King's Daughters

KD-3123.0-26

GC Services for UK King's Daughters Medical Center – Greenup Co. Urgent Care/Family Care Medical Office Building

ADDENDUM # 02

S-201

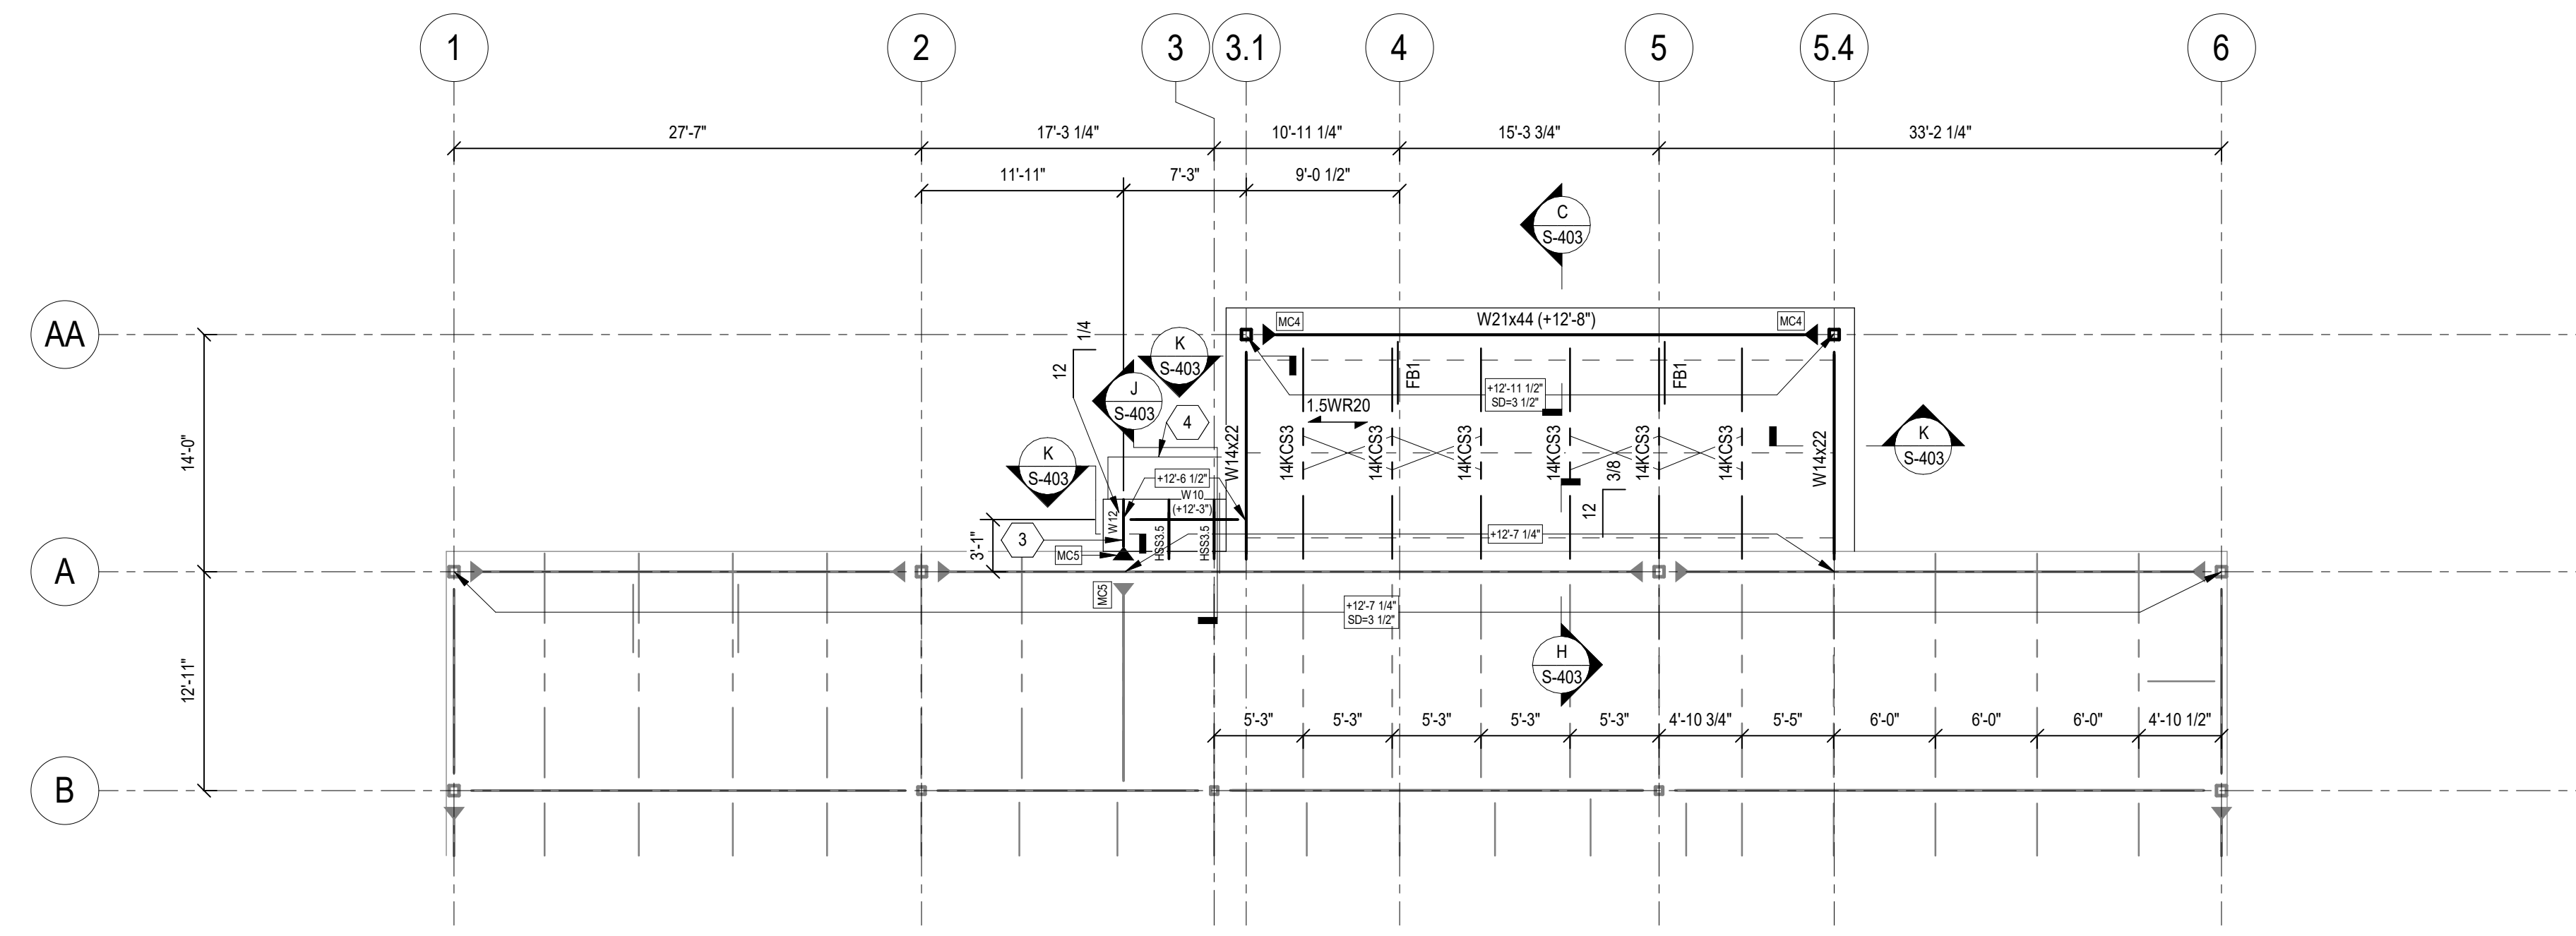
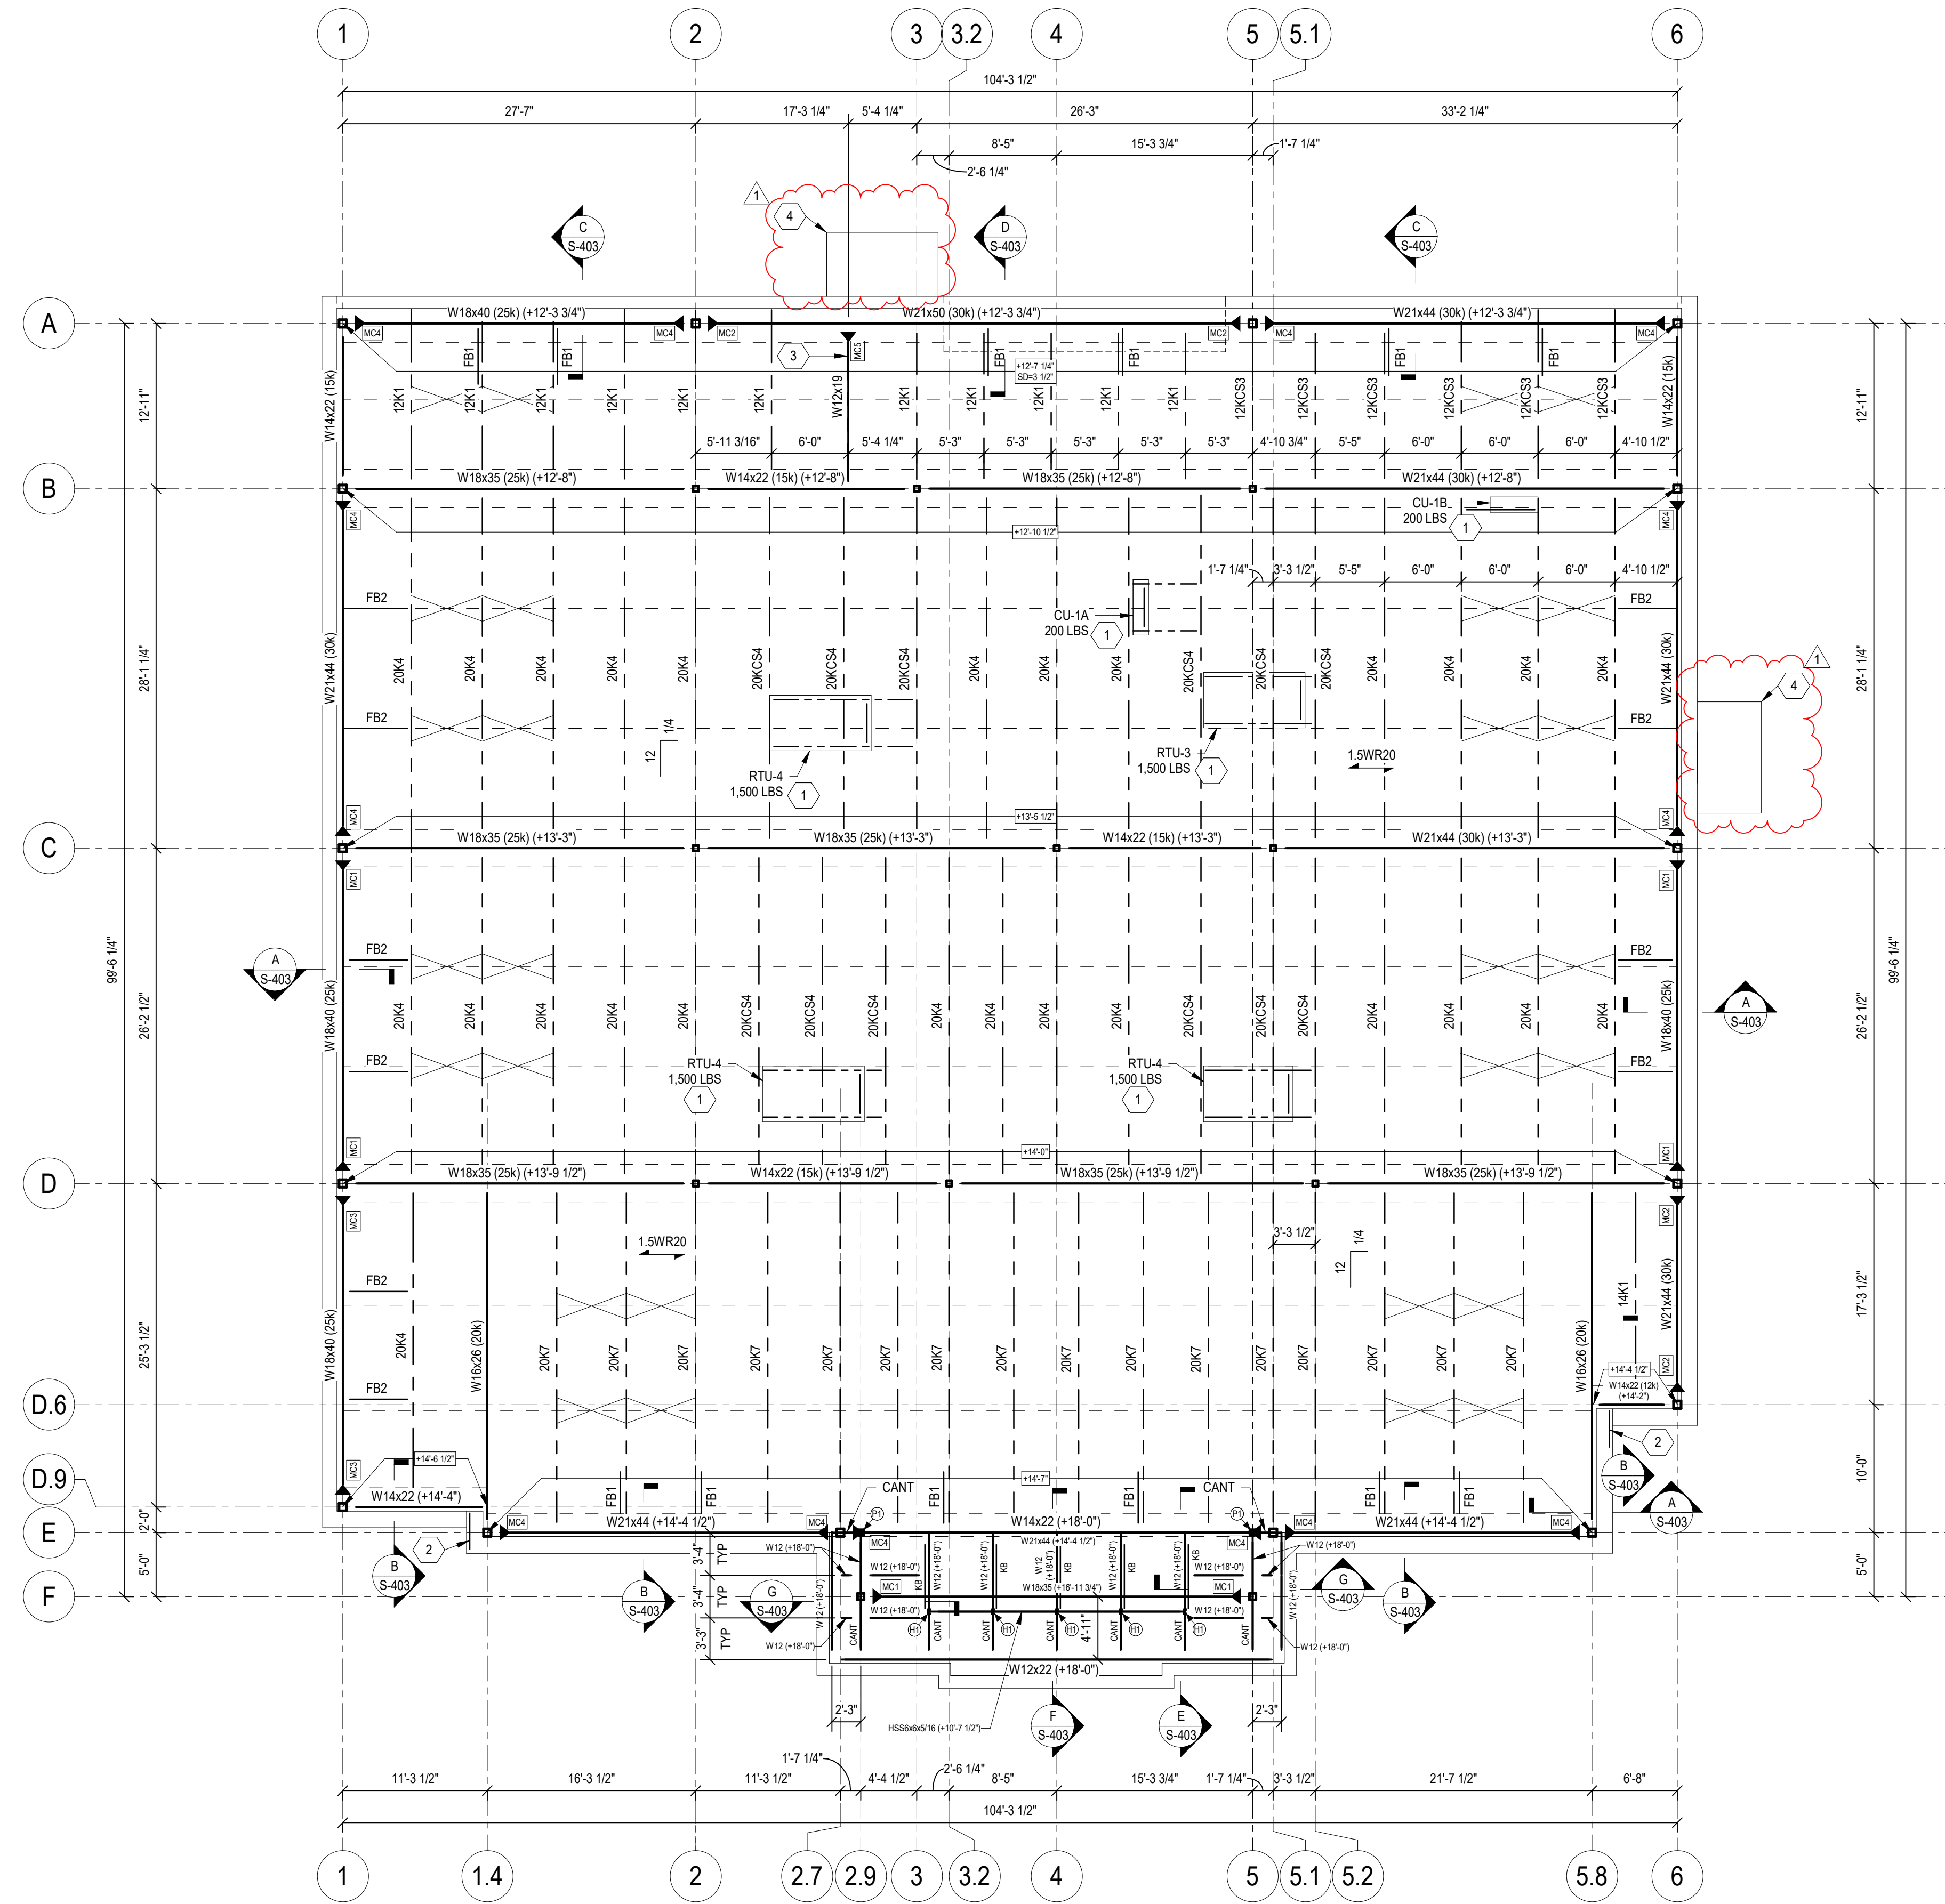
Refer to the attached revised Sheet S-201 for added slab recess information to coordinate with architectural drawings. A missing foundation tag was also added.

A-501

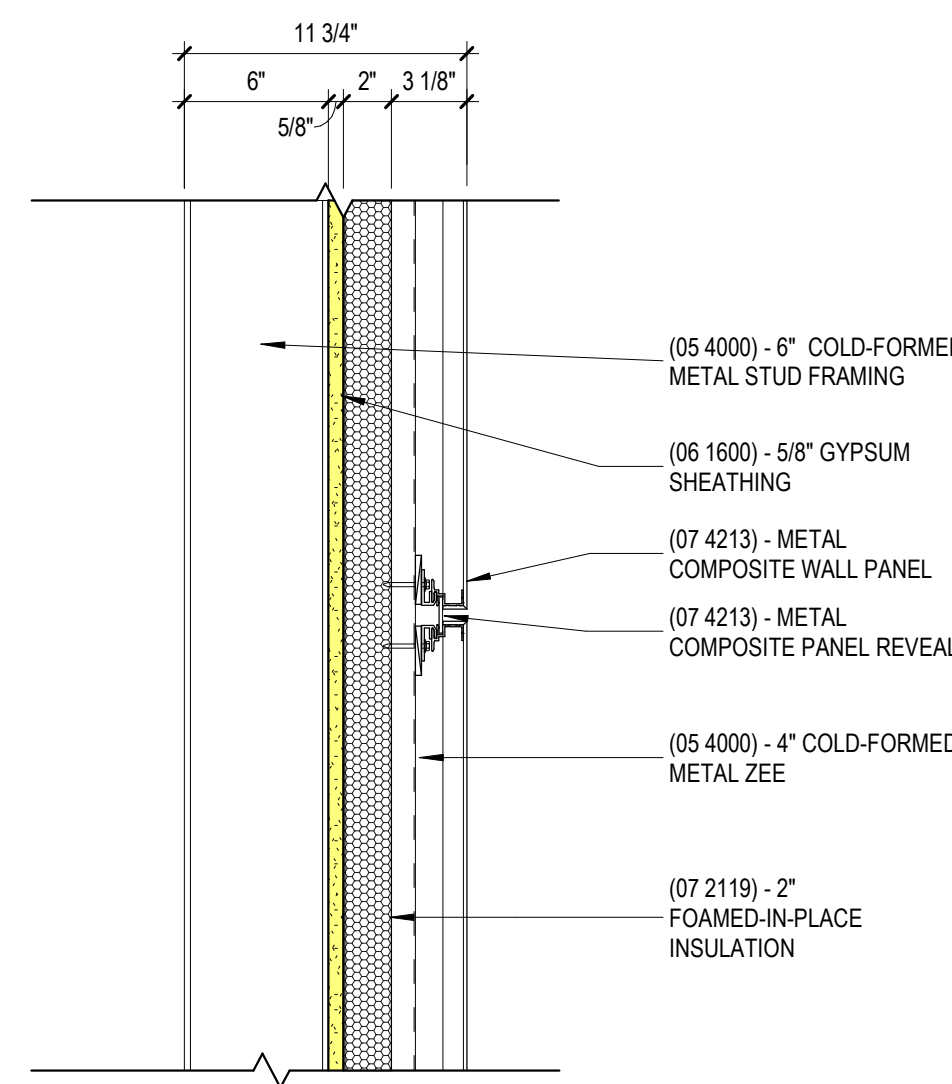
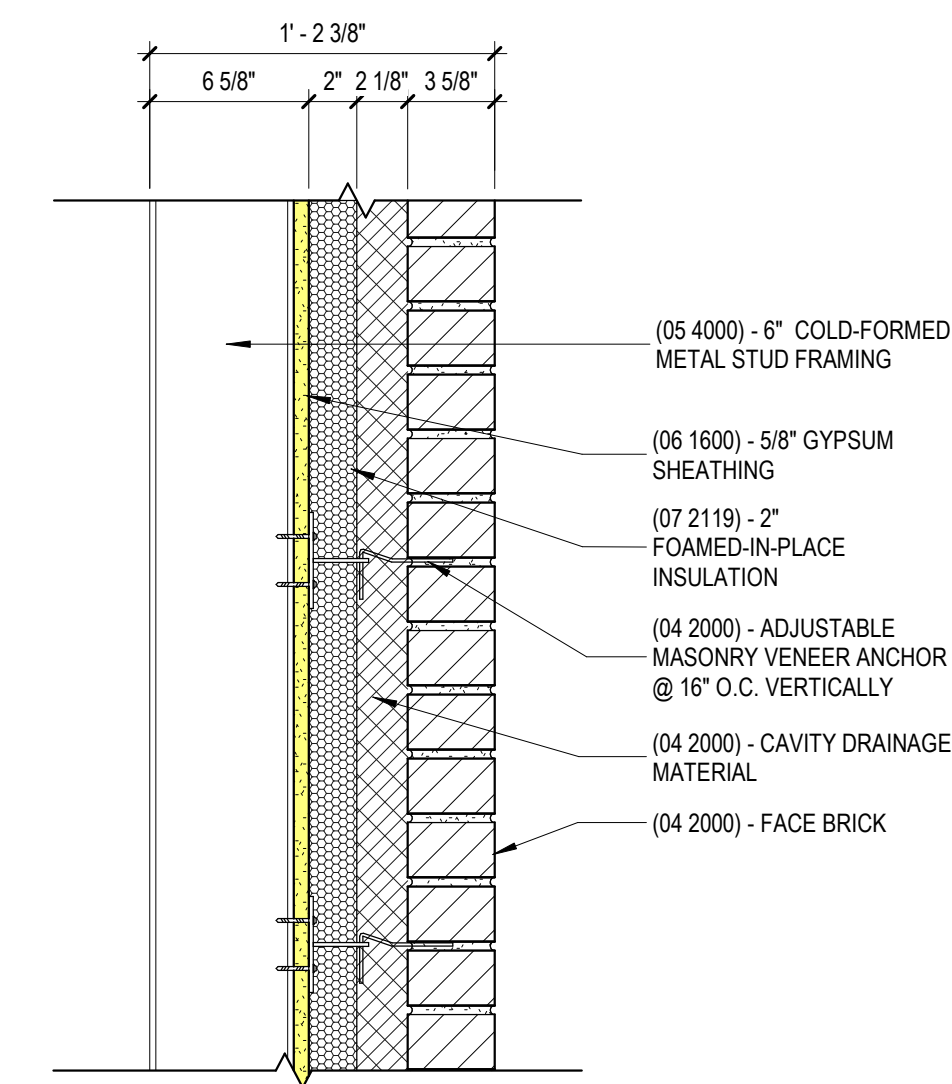
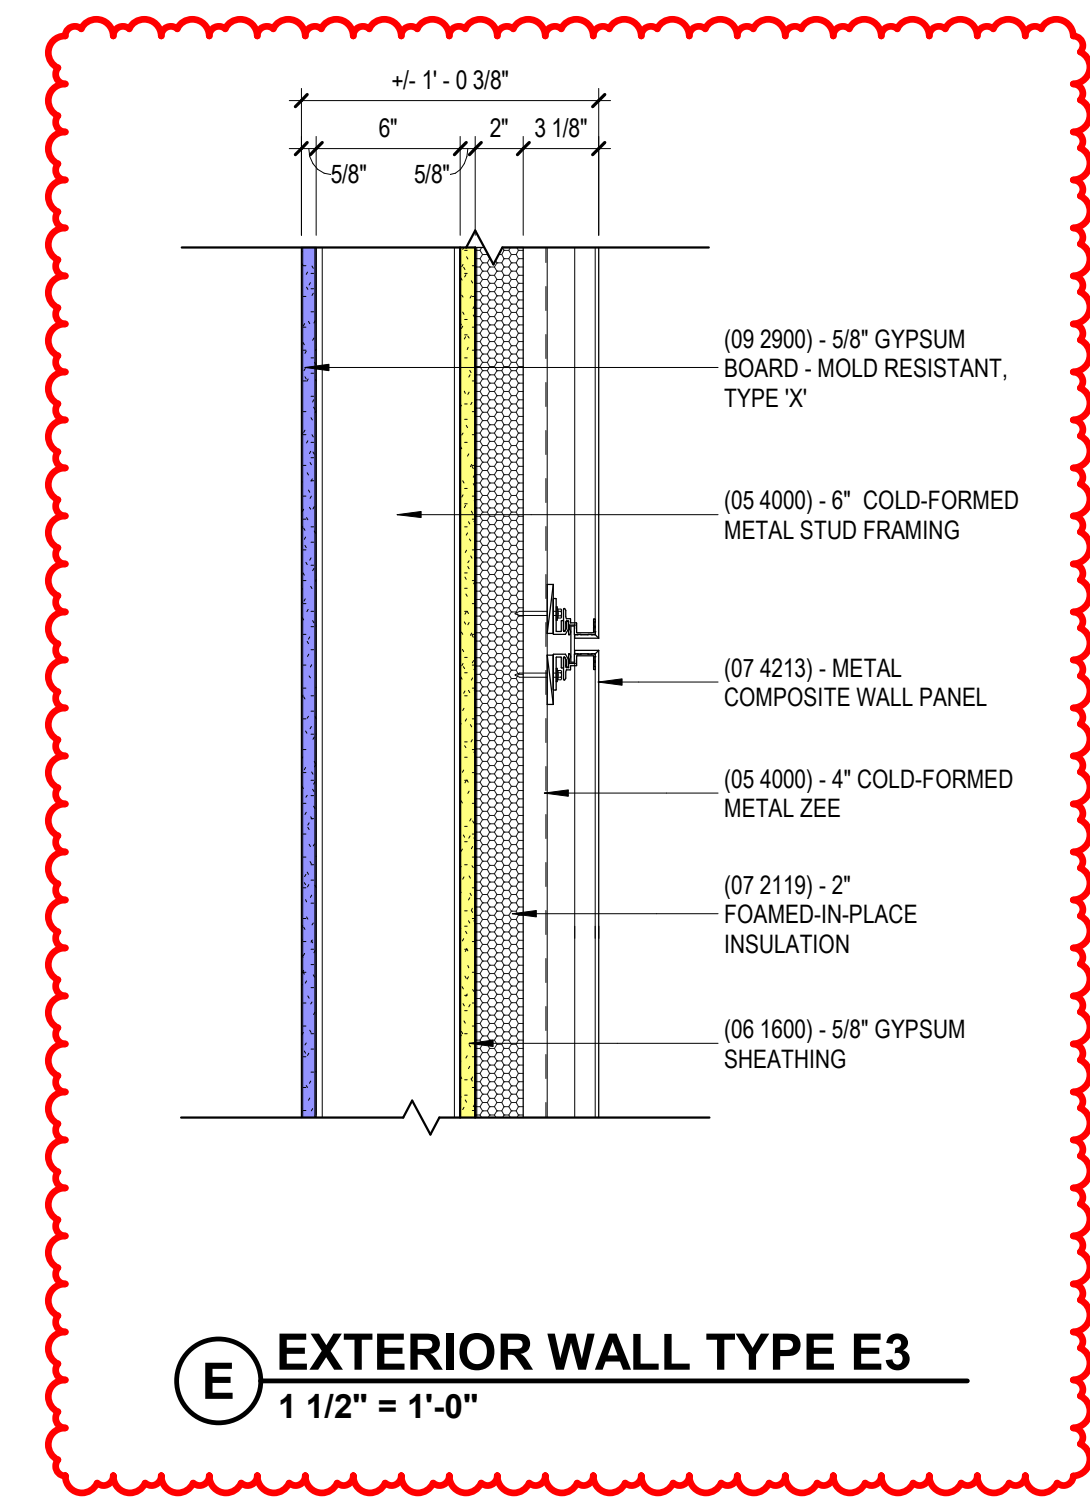
34	Please confirm Base Bid Landscaping is everything on L500 and Alternate No. 6 is an add for the plants only shown on L501. The Form of Proposal appears to have incorrect an sheet number.	Alternate No. 5 is as described on the Bid Form and illustrated on the Landscape Plan and Alternate Landscape Plan on L500. Alternate No. 6 is as described on the Bid Form, relating to all plant, mulches, landscaped beds as shown on L501 and details on L502
35	Sheet A-501/Detail A. Please clarify the thickness of the (04 2000) Cavity Drainage Material.	Refer to Specification Section 04 200 Article 2.11.E.1. The thickness is also illustrated on the drawings.
36	Sheet A-201/Exterior Material Schedule. Please specify the height, width, and length of the CSMU Band units.	
37	Sheet A-501, please provide detail for Exterior Wall Type E-3.	The wall type E3 referenced in this question has been renumbered E4. Refer to the attached revised Sheet A-201 and added Wall Type Detail on the attached revised Sheet A-501. Refer to Addendum 1 for Wall Type E3 locations and detail
